TECHNICAL MEMORANDUM

Project No. CA-GLD-1791470A

RESPONSES TO WELLINGTON SOURCE WATER PROTECTION REVIEW COMMENTS – PROPOSED CBM ABERFOYLE SOUTH LAKE PIT

The table below provides WSP's responses to review comments made by Wellington Source Water Protection (Wellington SWP) on February 8, 2024 and received by MHBC Planning from the Township of Puslinch on April 29, 2024 related to the ARA licence application for the proposed CBM Aberfoyle South Lake Pit.

Figure 1: Numerical simulation results predicting an area of post-rehabilitation groundwater uplift, which could create minor flooding in during seasonal periods of a high water table.

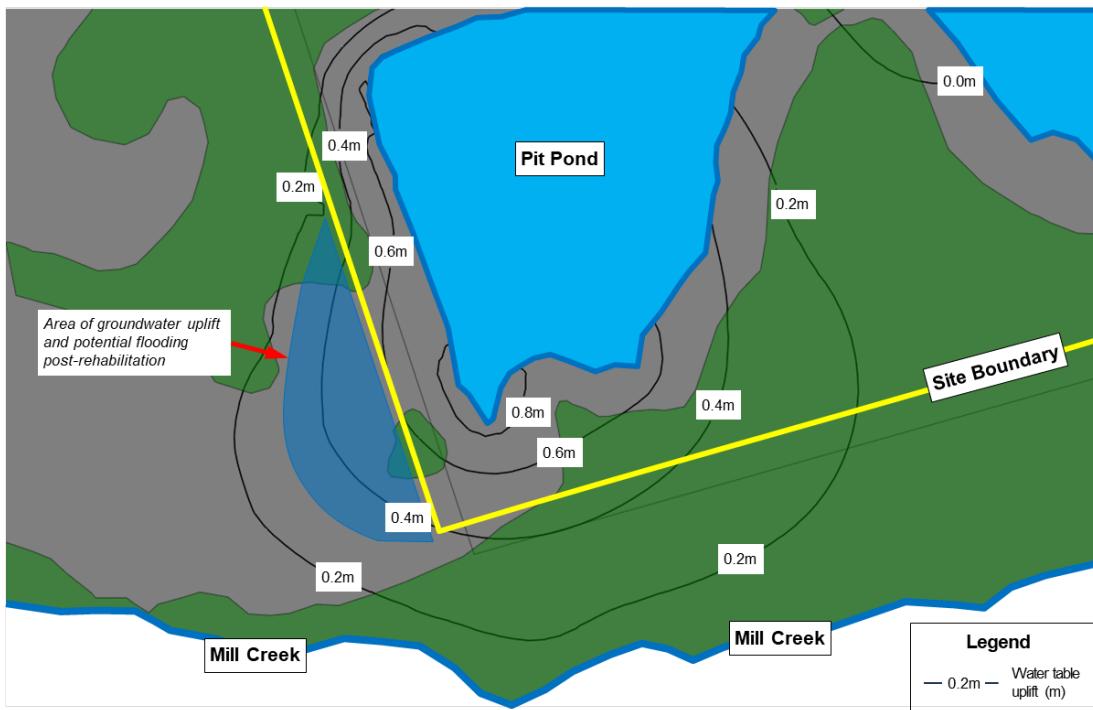
Numerical modelling simulations predict post-rehabilitation groundwater uplift at the site of approximately 0.6 m to occur immediately southwest of the proposed pit pond beyond the property limits, as shown on Figure 1. While the steady state groundwater level in this area is predicted to be below the ground surface, when seasonal variability is considered (approximately +/- 0.3 m annually at nearby MW18-01B) there is a potential for occasional flooding to occur on adjacent low lying lands during periods of high groundwater levels (e.g. during the spring freshet).

Figure 1: Surface Water Stations on Mill Creek and Tributary 3 (SW1 to SW4), and modelled surface water stations (SW-M1 to SW-M3) at the confluence of Tributary 3 and Mill Creek.

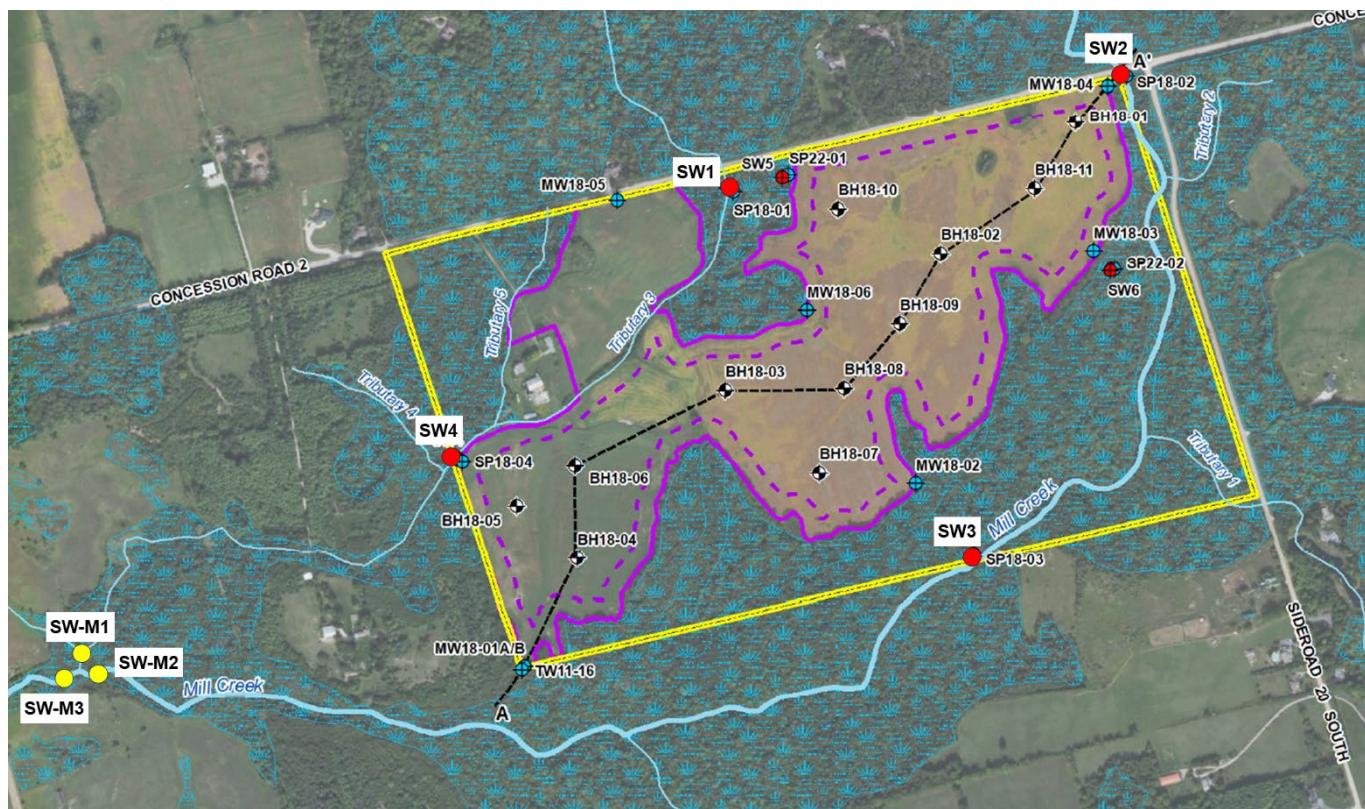
A number of comments from stakeholders expressed concern regarding the potential for impacts to baseflow in Mill Creek and Tributary 3 as a result of the proposed aggregate pit development post-rehabilitation. This technical memorandum provides a supplemental assessment of these potential impacts, in order to provide clarity and context to the predicted changes to baseflow.

To clarify and further illustrate the redistribution of baseflow as originally described in the Water Report, modelled surface water stations (SW-M1, SW-M2, and SW-M3) were introduced at the confluence of Tributary 3 and Mill Creek, downstream of the area of redistributed baseflow, at the locations shown on Figure 1. These simulated stations were added without any alteration or recalibration to the model. The resulting baseflow predictions for the previous and new modelled surface water stations under current conditions and post-rehabilitation are shown in Table 1 and discussed below.

Overall, the net change in baseflow to the system as a whole in the vicinity of the site as simulated at the confluence of Tributary 3 and Mill Creek is predicted to very small, about 0.1%.

Figure 2: PSW Zonation and Groundwater Drawdown under Rehabilitated Conditions

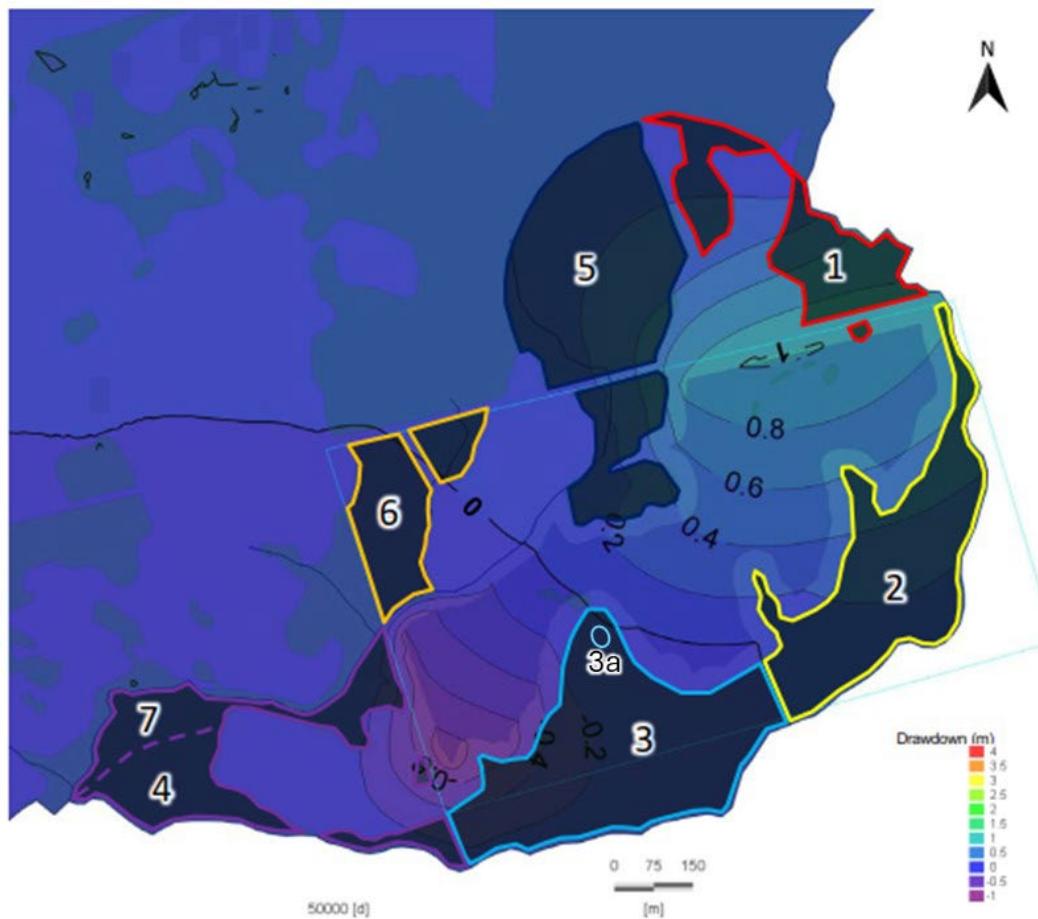
Stakeholders have expressed concern regarding the potential for impacts to Provincially Significant Wetlands (PSWs) as a result of the proposed aggregate pit development during operations and post-rehabilitation. This technical memorandum provides a supplemental assessment of these potential impacts, in order to provide clarity and context to the predicted changes to wetland hydrology and ecology as a result of this proposed aggregate extraction development, and accordingly provides supplemental impact assessment.

Hydrological potential for impacts are considered on a scale of decreasing severity from significant, moderate, minor, minimal, negligible, to none. Impacts during operational periods to each zone (Figure 2) are summarized below and in Table 3.

- Zone 1: This zone experiences no change to direct precipitation, surface water, or runoff inputs, but does lose some groundwater discharge as a result of water table flattening. Minimal potential for impact is anticipated.

- Zone 2: This zone experiences no change to direct precipitation. However, there is a reduction in runoff and groundwater discharge, which are minor contributors to the PSW in this zone under current conditions. Minor potential for impact is anticipated in post-rehabilitation conditions.

- Zone 3 and 3a: This zone experiences no change to direct precipitation and a slight increase in groundwater discharge in post-rehabilitated conditions. There is a reduction in runoff from the reduced catchment, which was a minor contributor to this zone. The increase in groundwater input is considered to offset the minor loss of runoff, and therefore negligible impacts is anticipated in post-rehabilitation conditions.

Figure 1: Monitoring Locations

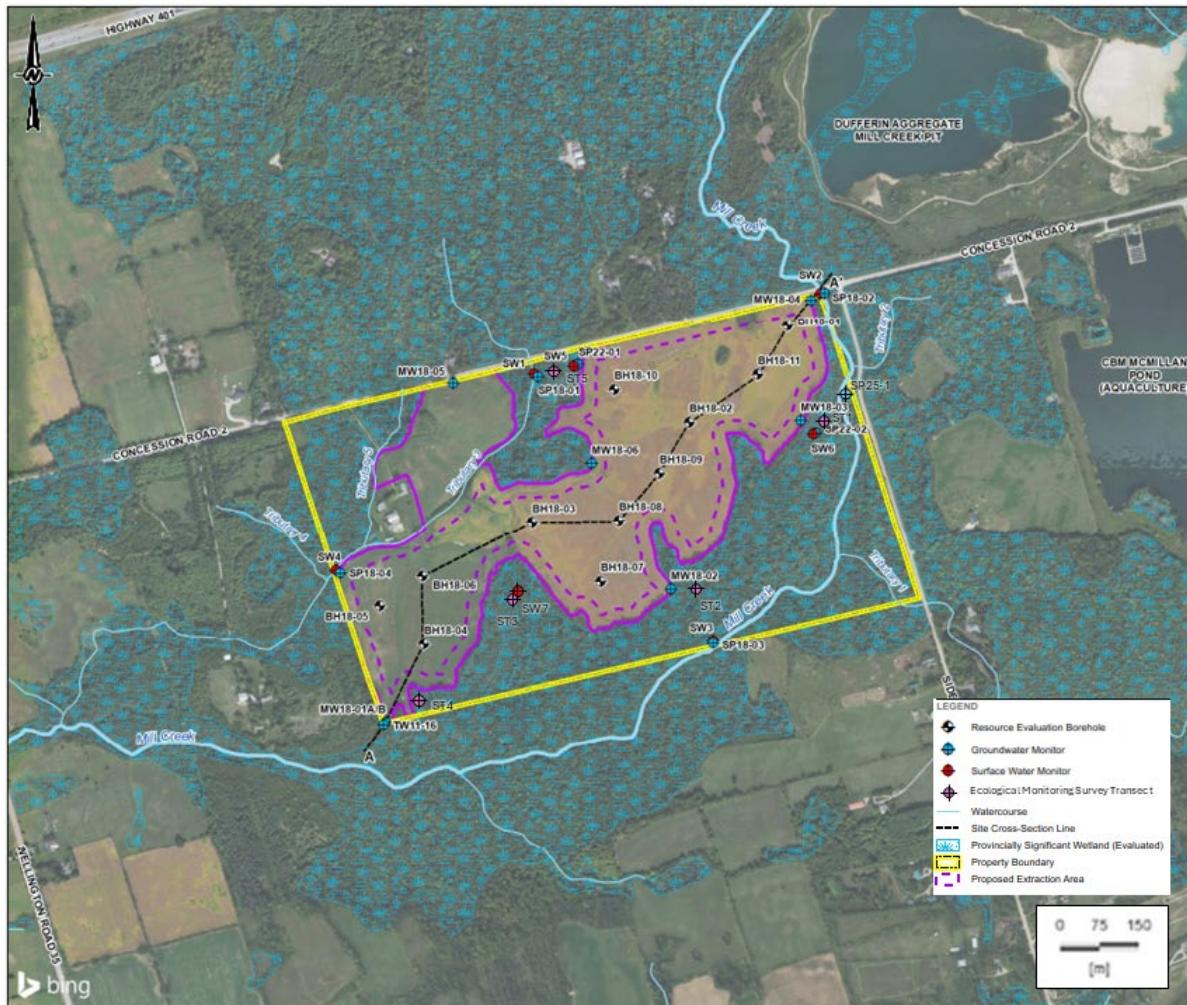
In response to stakeholder comments to the Water Report, WSP has prepared this Technical Memorandum which presents an enhanced site-specific monitoring plan, provides an approach to the establishment of trigger conditions (to be determined specifically based on all available baseline data prior to the Operational Phase), and identifies potential corrective actions. Monitoring locations are presented on Figure 1.

- A new groundwater monitoring location shall be established to the east of Mill Creek, labeled SP25-1 on Figure 1, to observe groundwater conditions. Once installed, this location shall be included in the groundwater monitoring network described above.
- Groundwater quality monitoring is not proposed, as no water quality impacts are predicted.
- A Well Interference Complaint Response program shall be implemented to respond to any potential interference with other water users, as described in the Water Report (WSP, 2023).

- To observe ecological conditions in the PSW, monitoring of the form and function of the wetland shall be carried out annually (in early summer) along five survey transects as depicted on Figure 1 and detailed below in Recommended Ecological Monitoring Method. Ecological monitoring shall begin one year prior to the start of aggregate extraction, and continue during the Operational Period, and end one year after the completion of site Rehabilitation. During the one year of monitoring prior to the start of aggregate extraction, monitoring will be carried out biannually (early summer and early fall) to provide baseline data for comparison to enhanced monitoring in the event this is required (as discussed below).
